# CITY OF PORTLAND

## BUILDING PERMIT

Job ID: 2012-06-4281-ALTR

has permission to replace existing deck with a 10.5' x 16' screened-in porch (Single Family Residence).

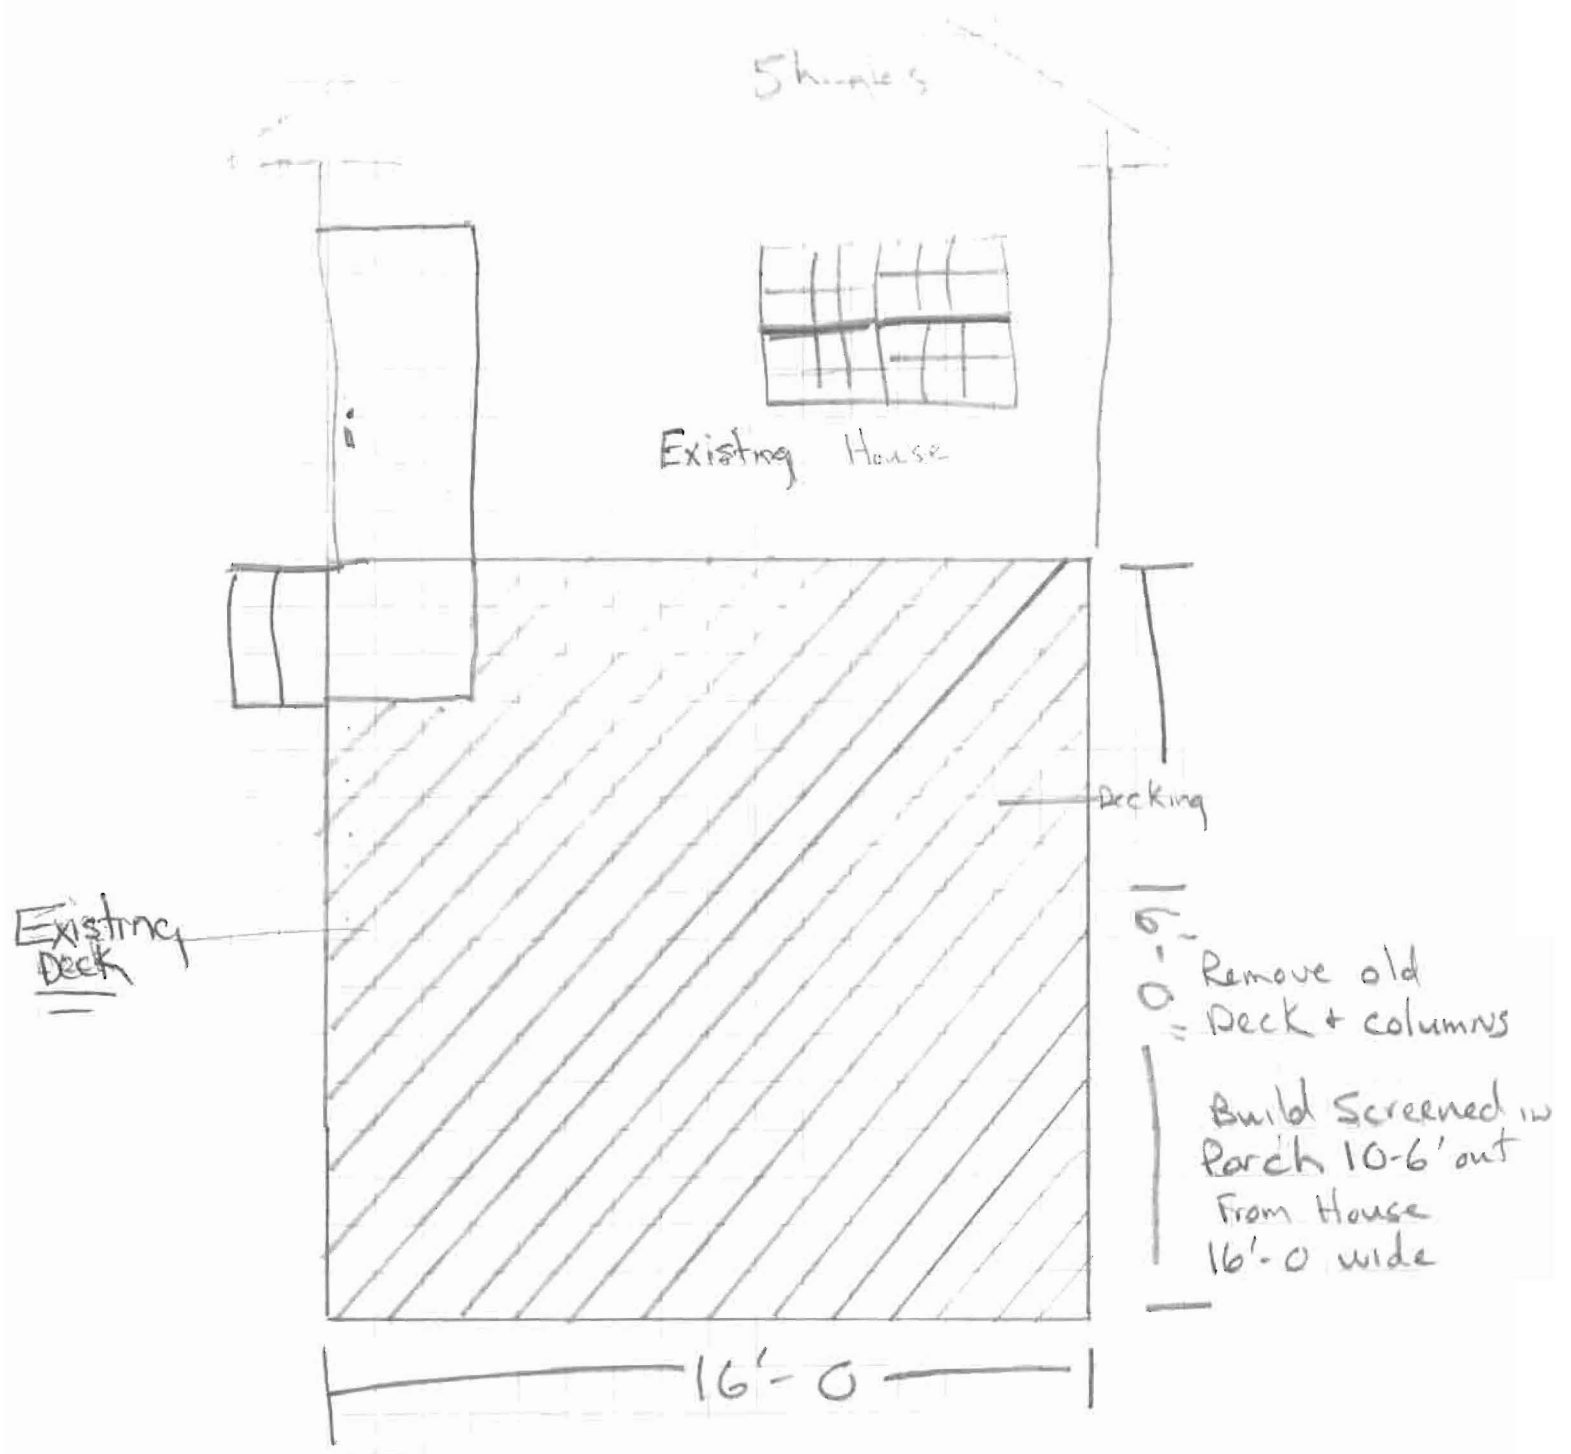
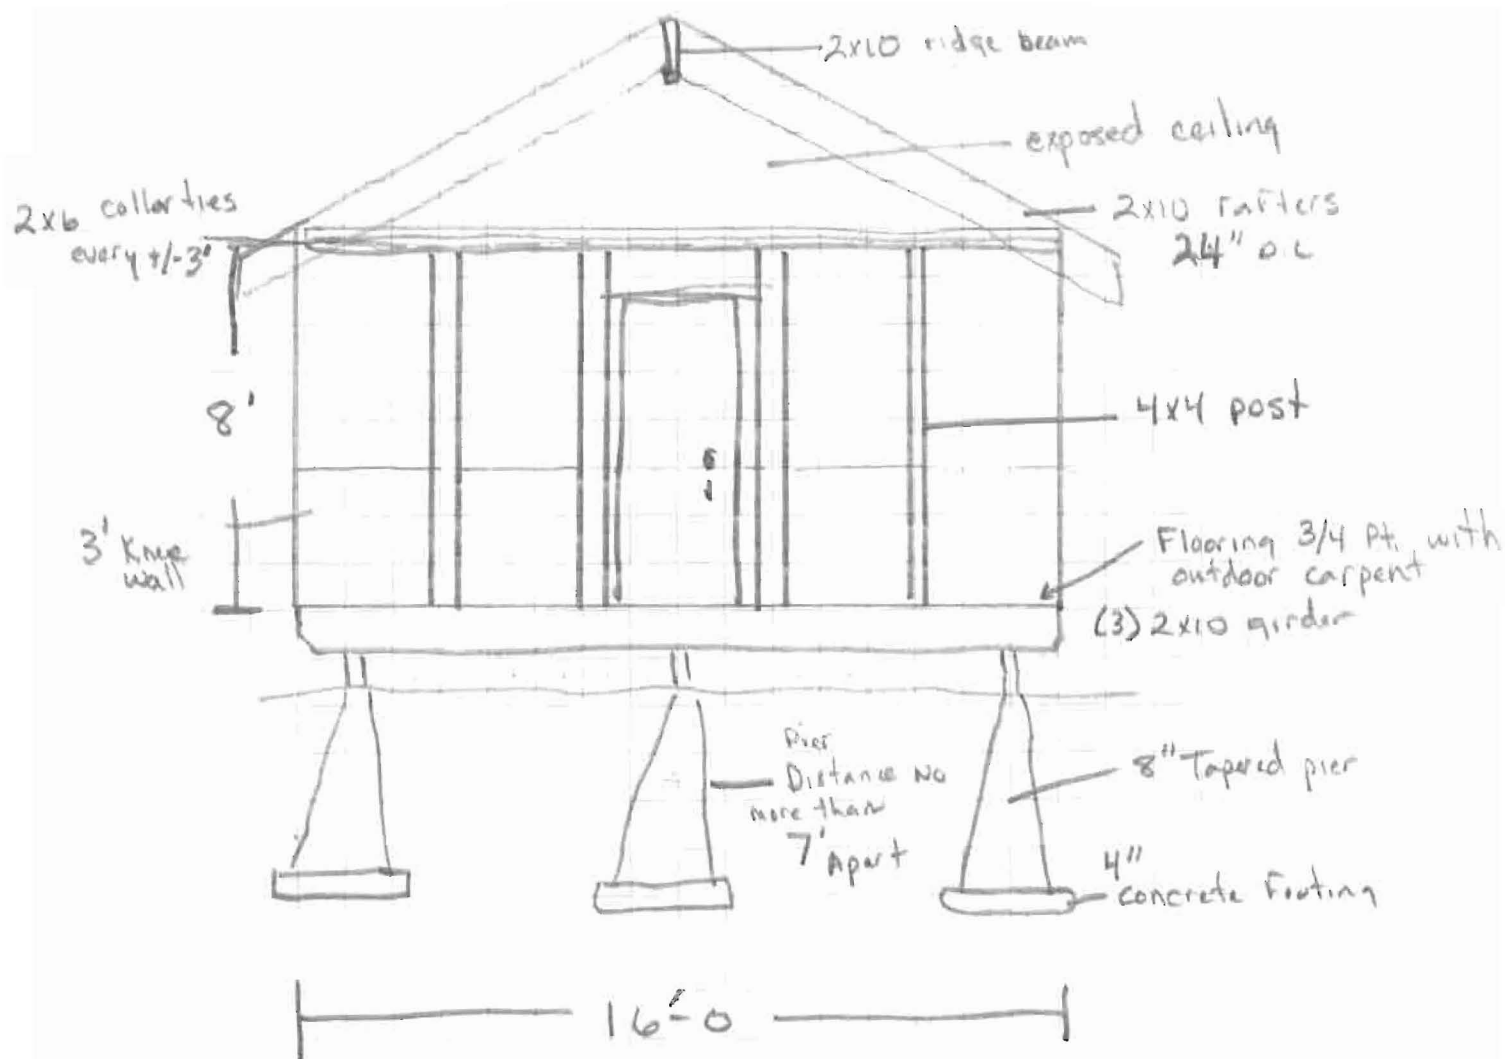
2. Section R317 Protection of Wood and Wood Based Products against decay. All wood framing members that rest on concrete or masonry exterior foundation walls and are less than 8 inches from the exposed ground.

3. A graspable handrail (34-38 inches in height) shall be provided on at least one side of each continuous run of treads or flight with four or more risers. Fall protection (36 inches) from exterior decks may be required if floor joist are at or above thirty (30) inches from grade.

4. R502.6 Bearing. The ends of each joist, beam or girder shall have not less than 1.5 inches of bearing on wood or metal and not less than 3 inches on masonry or concrete except where supported on a 1-inch-by-4-inch ribbon strip and nailed to the adjacent stud or by the use of approved joist hangers.

5. R502.5 Allowable girder spans. The allowable spans of girders fabricated of dimension lumber shall not exceed the values set forth in Tables R502.5(1) and R502.5(2). This shall include the screened porch openings on the load bearing exterior walls.

Plot Plan

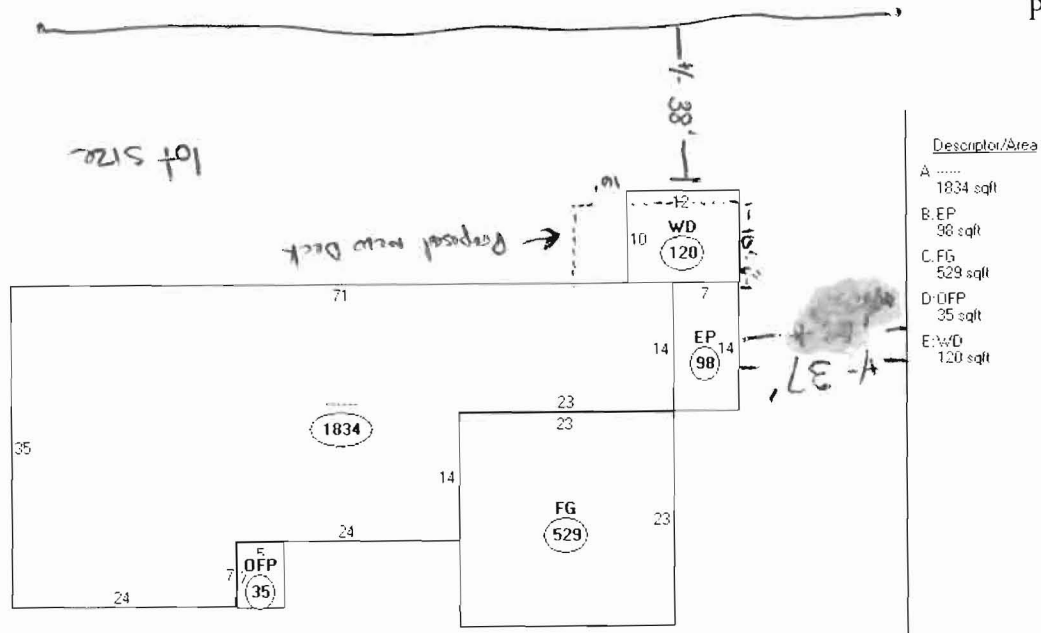
1) NEED VF CABLE OR  
COVER NM UNDER PORCH

2) SAFETY SLIDING @ WINDOW ADJ TO DOOR
